Ibrahim Knit Garments (Pvt) (9688)

23.APRIL.2014

Identified Priority 1 Concerns

Drawing vs. Construction Discrepancy

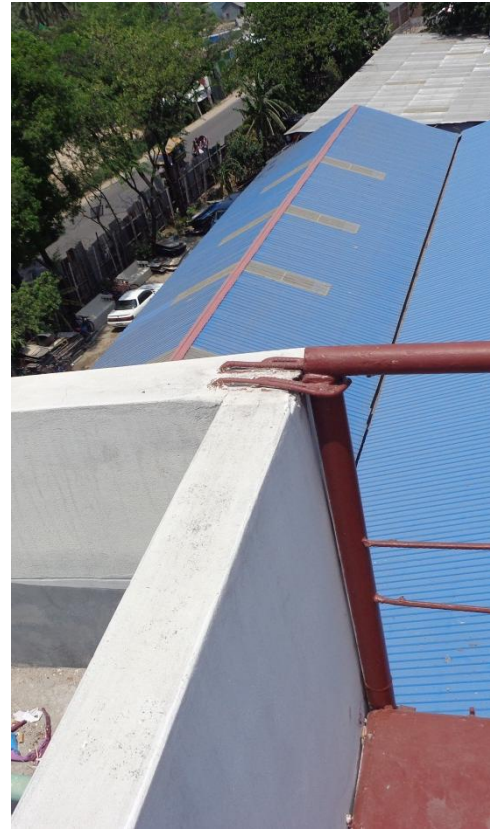
Structural drawings show beam/slab configurations that differ from those observed in all buildings, column sizes in the 6 Storey building differed from those shown on Structural details. Additionally, where beams were present, the beam sizes differed from the Structural drawings provided.

- Commence a Detailed Engineering Assessment to review the adequacy of as-built construction. Assessment to include formulation of as-built drawings and verification of reinforcing steel.
- The DEA is to include lateral stability checks for all factory buildings.
